RE: Submission of 2019 Geotechnical Inspection Report No. 1 (July 2019)

Annual Geotechnical Inspections – 2019 Report 1. Mary River Iron Mine Complex – Nunavut

August 31, 2019
TC190307

Figure 6: Aerial view of the three PWS ponds

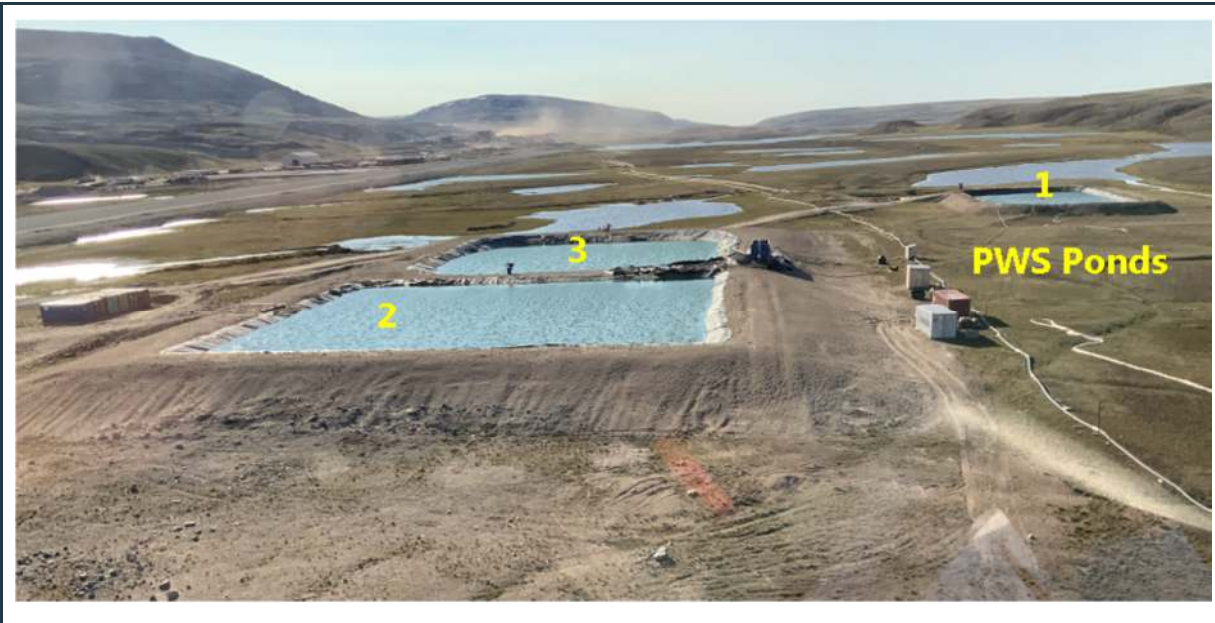
The berms around the ponds generally comprise granular soils (sand and gravel), supporting High Density Polyethylene (HDPE) geomembrane liners. The liners are secured in anchor trenches on the crest of the berms, and no damage is visible on the membranes on the upstream face of the slopes. However, there are some minor damages visible on the liners on the crest of the berms (above the maximum water/freeboard line) at a few locations, as shown in Figure 7 (see red circles). These minor damages should be repaired as part of the regular maintenance program.

As show in Figure 6, the berms around the three ponds appear to be stable, having shallow downstream slopes. They were built by using non-frost-susceptible well compacted granular materials (dense state of compactness based on visual inspection and manual probing). Based on surficial site observations, it appears that the subgrade around the berms comprise thaw-stable granular soils with trace to some fines. With this observation, the berms are assumed to have stable foundations, which is further supported by the fact that there are no indications of differential settlements, sinkholes, sloughing, etc. at the perimeter berms. However, at a few locations truck-tire related damages (e.g., depression on the crest's surface and related densification) were observed (see yellow circles in Figures 7 and 8) at the top of the berms. These are assumed to be caused by discharging activities. It is advisable to backfill these depressions with compacted sand and gravel until these areas match the crest elevations elsewhere. Prior to fill placement all visible minor damages to the liners shall be repaired.

A relatively common issue in water lagoons is the appearance of "whales" within the ponds. Whales are sections of the liners which have risen above the surface of the water, particularly in shallow ponds where the weight of water above the liner is minimal. Such a "whale" was visible during the inspection at PWS pond #3, as shown in Figure 9. The presence of whales ("liner bubbles") is usually attributed to suspected to potential gas generation beneath the liners due to decomposition of organics in topsoil layer that may have been left in place beneath the liner away from berm foundation during construction, resulting in the formation of whales. Such whales had been recorded in the past in some of the ponds at the subject mine site. However, no damage to the liners or seepage from the ponds has been reported, including the current survey/inspection. Should the affected pond be drained in the near future, it is recommended that the gas from beneath the liner be released by poking holes and repairing the liner in the next step.

Baffinland Action: Baffinland commits to having the minor damage to the liner repaired as part of the regular maintenance program. Baffinland will continue to monitor the PWSPs for the presence of whales in the liner, and as needed will develop a plan to address these when the affected pond is drained. Cleanup of this area will occur to remove excess materials.

Figure 19: View of HWB-7

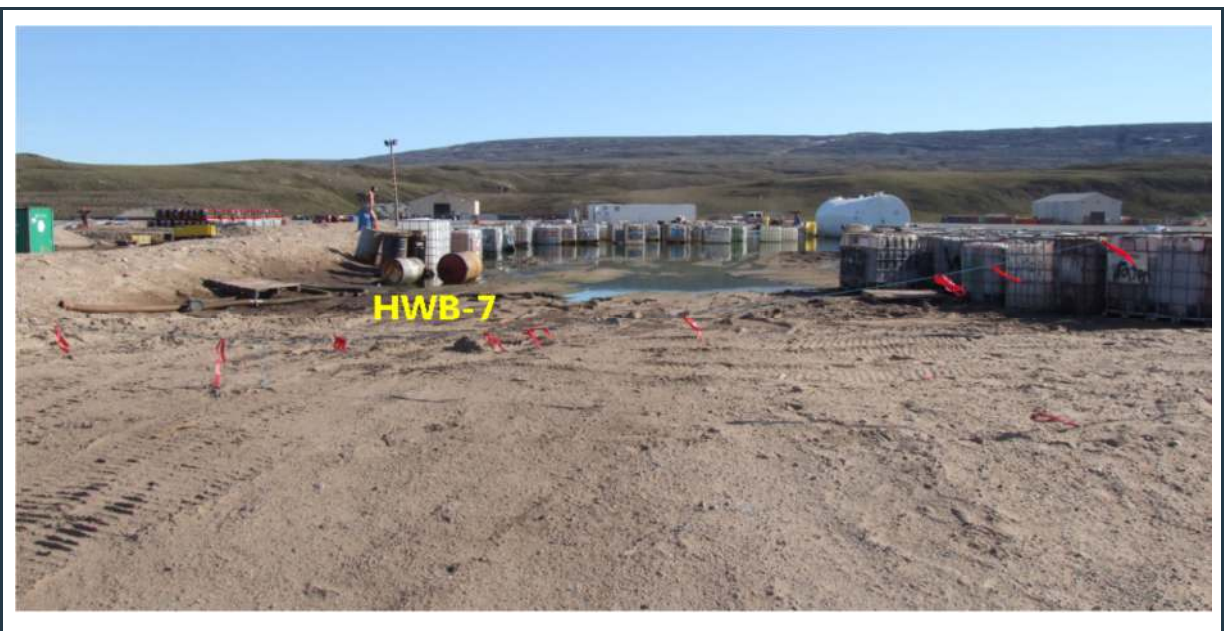
Based on information from historic reports, the HWB-7 cell was a bulk fuel storage facility in the past. Currently it is used to store fuel barrels, lubricant totes and a large fuel tank, as shown in Figures 18 and 19. The perimeter berm around three sides of the cell appears to be stable and the visible water within the cell supports adequate liner performance. There is a ramp along the fourth side of the cell (with appropriately high elevation at its highest end) to provide truck access into the cell.

Figure 22: Surface water collection ditch with clogged culvert

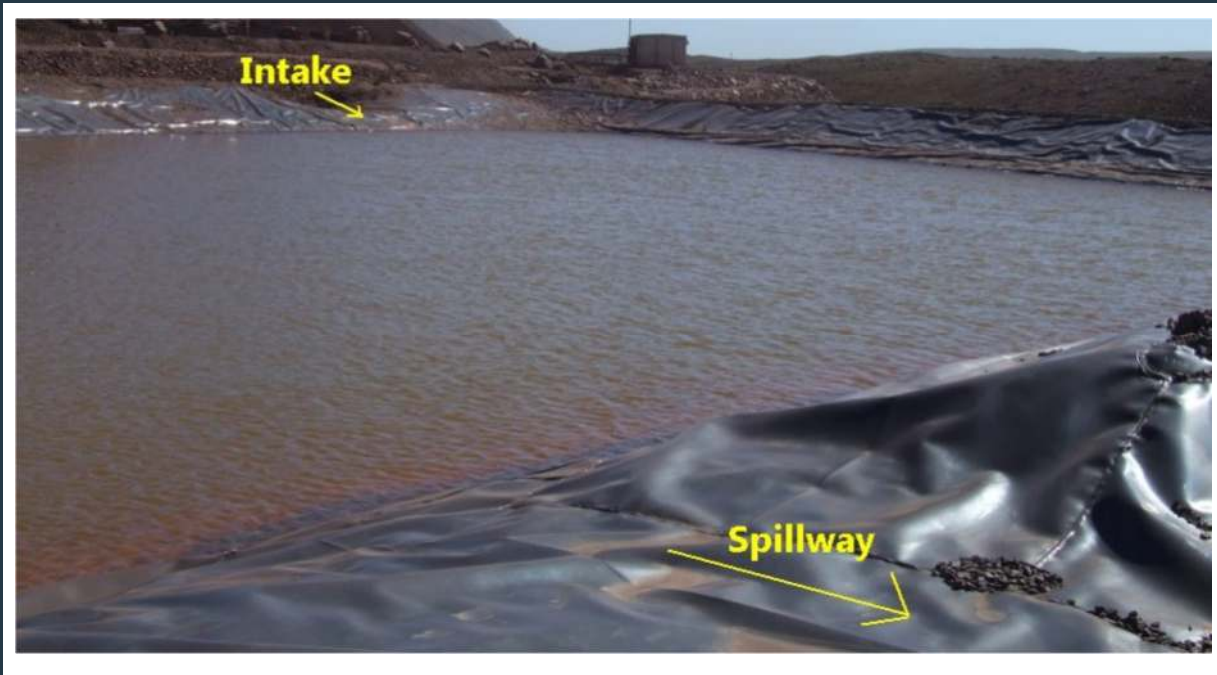
As shown in Figure 22, the corrugated steel pipe culvert beneath the tote road is almost fully clogged with silt. It is recommended that the culvert be cleaned, and the collected excess silt be deposited at appropriate location on site. Excessive amount of collected silt within the ditches should also be removed periodically and the material disposed at appropriate location on site. As shown in Figure 23, ponding surface water is visible above the silt within one of the ditches, located between the tote road and the MS-06 pond.

Figure 25: View of the MS-08 pond downstream of the waste rock dump

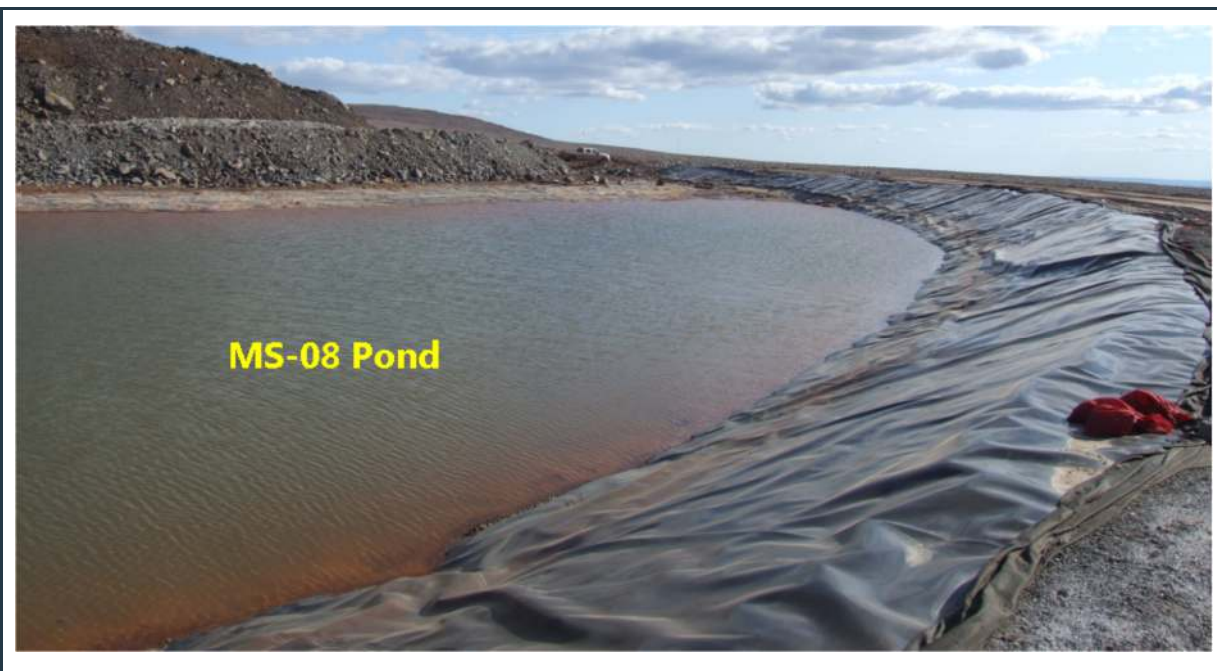
The MS-08 sedimentation pond is surrounded by a crescent shaped semicircular berm to the east, north and west and by the waste rock dump to the south, as shown in Figures 25 and 27 in Appendix A. Contact water from the waste dump area flows directly into the pond (see Figure 27) from the south, and conveyed to the pond via open ditches from the other sides of the dump. As shown in Figure 26, the construction of drainage ditches to allow for more flow capacity / minimize erosion is in progress.

Figure 28: Water treatment pond adjacent to the waste rock dump and MS-08

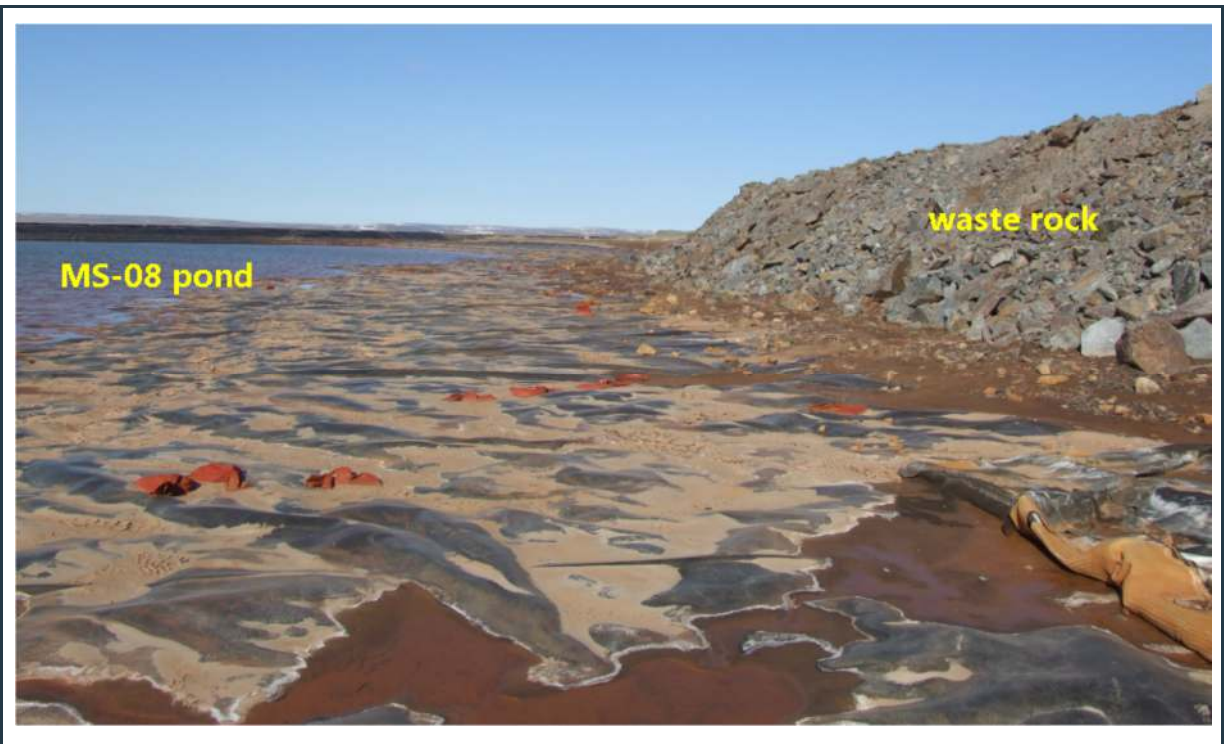
As pointed out above, the water from the pond is pumped to the nearby designated facility for treatment. There is a lined treatment area located immediately next to the plant with stable perimeter berms, as shown in Figure 28. No issue with this treatment area was ever recorded and the entire facility is in excellent condition.

Figure 44: Small area of ponding water within the HWB-2 cell with locally exposed liner

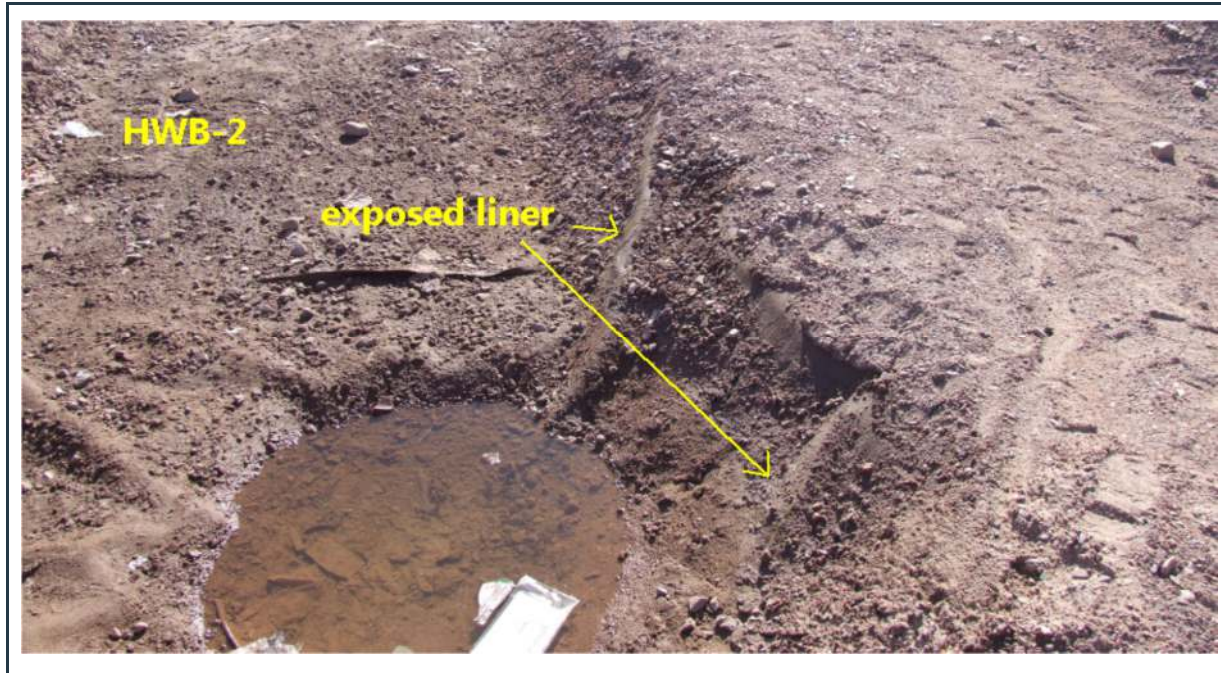
The HWB-2 is a small cell that is currently empty. As a result of some recent earthwork immediately adjacent to the cell, sections of the perimeter berm have been impacted, and the slopes and liner were somewhat damaged in the process. There is a small area in one of the corners with ponding water, where the liner is exposed, as shown in Figure 44. It is suggested that the soil cover from above the damaged liner and the liner itself be removed and disposed into the HWB-1 cell. As an alternative option to the full decommissioning the perimeter berm shall be reconstructed and the liner carefully repaired.

Figure 49: Berm in excellent condition with stable slopes around the MP-01A pond

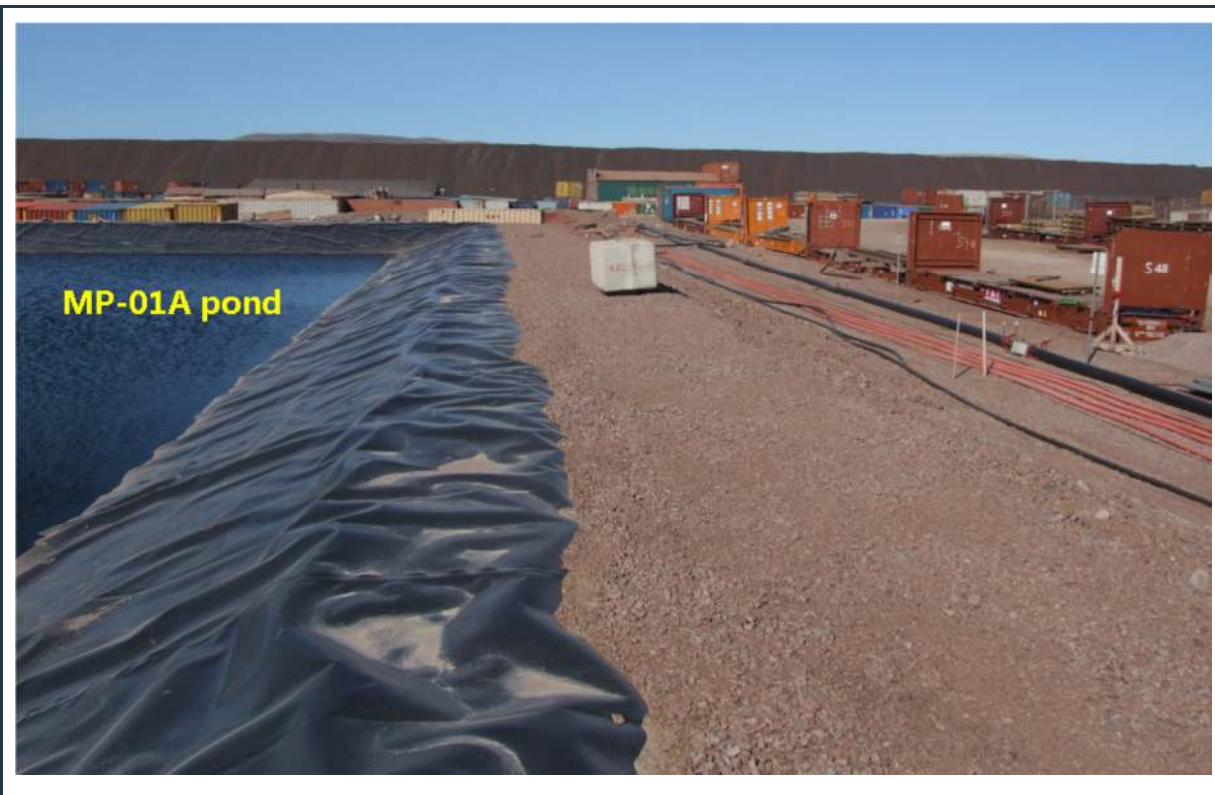
The new (2014) MP-01A polishing waste stabilization pond is located immediately south of the MP-03 fuel tank farm. As shown in Figure 49 the berm around the pond is in excellent condition and the liner appear to be intact. No sign of slope instability, settlement or seepage from the pond was noted during the field inspection.

Figure 81: One of the "old" abutments at bridge 97. The section above the red-line may be removed, but the removal is not necessary.

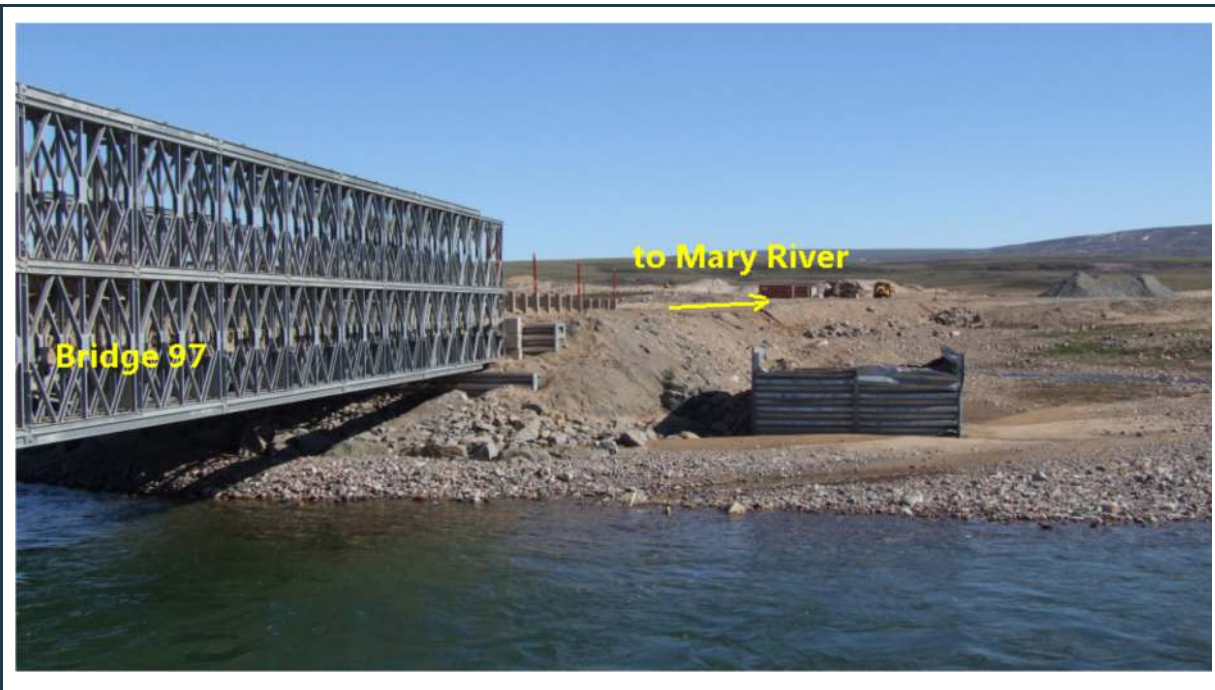
As shown in Figure 80 and 81, the abutments of this bridge are stable and no scour in the river-bed was noted during the site visit. The abutments show no differential settlement or any structural discrepancy like cracking on the foundation concrete.

Figure 48: Stable berm at the MP-04 landfarm, with exposed liner on the downstream slope.

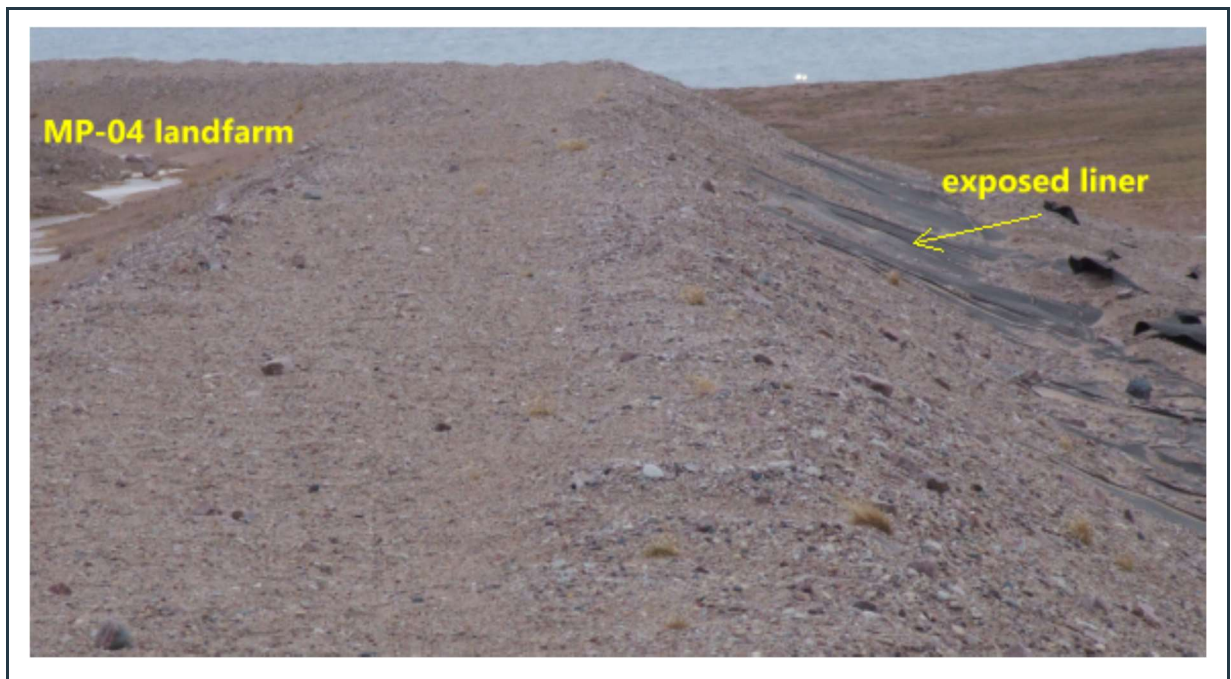
The MP-04 and MP-04A cells are located south of the port complex at higher elevation, adjacent to the rock quarry. MP-04 is a large landfarm cell that predominantly stores contaminated soils, as shown in Figure 47. The berm structure around the cell did not exhibit any signs of instability or evidence of seepage. However, the liner was found to be exposed (e.g. lacking protection of soil cover) on the downstream slope sections of the berm. This was particularly prominent along the north berm. It is recommended that the respective exposed liner areas (see Figure 48) be provided with protective gravel layer (e.g. wind uplift prevention).
